Airmont Community Meeting

April 11, 2013

Summary of Responses to Airmont Community Questions

EARTH BERM - VISUAL SCREENING

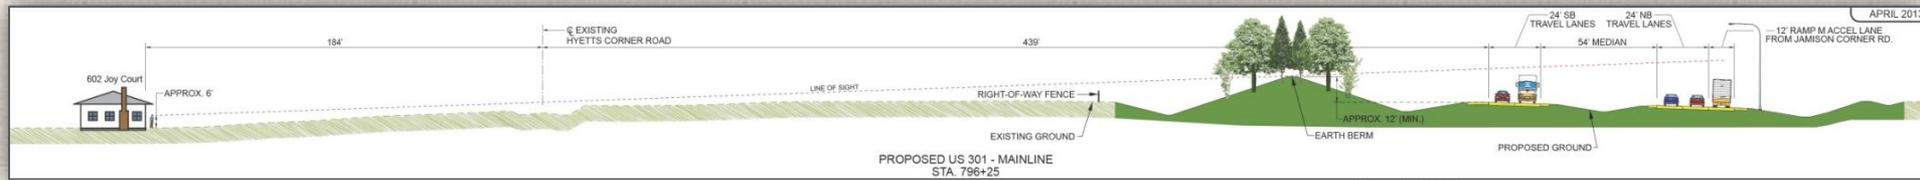
- ❖ As noted in the November 2007 FEIS, the initial landscaped visual earth berm proposed for the Airmont community was 6' high and extended 1,670'.
- ❖ In November 2011, during the Airmont community meeting, DeIDOT indicated that as part of the design refinements effort, the berm was being modified to be 12' high and would extend 2,000', the full length of the community.
- ❖ The increase in berm height was possible without increasing construction costs.

- ❖ All landscaped visual earth berm heights were assessed primarily for effective visual screening and the potential to reduce noise levels.
- ❖ A 12' high landscaped berm will provide more than 12' of vertical screening coverage to the residences in Airmont.
- ❖ Proposed landscaping will provide additional visual screening.

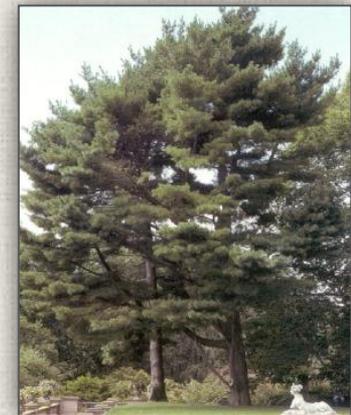
- ❖ As requested by the Airmont community, the core or backbone of the planting will be evergreens, to provide screening throughout the year.
- ❖ The planting design on the berm utilizes a mix of evergreen trees (such as Hollies, Pines and Junipers), major deciduous trees (such as Oaks, Maples and Sycamores), and minor deciduous trees (such as Hawthorn, Witchhazel and Magnolia).
- ❖ This provides a variety of sizes and foliage density to create an effective screening for all seasons.
- ❖ Trees will be planted on both side slopes of the berm and along the Off Ramp P from southbound US 301 to Jamison Corner Road.
- ❖ Additional landscaping is being planted by the Road 412A contractor at the southwest corner of the community.
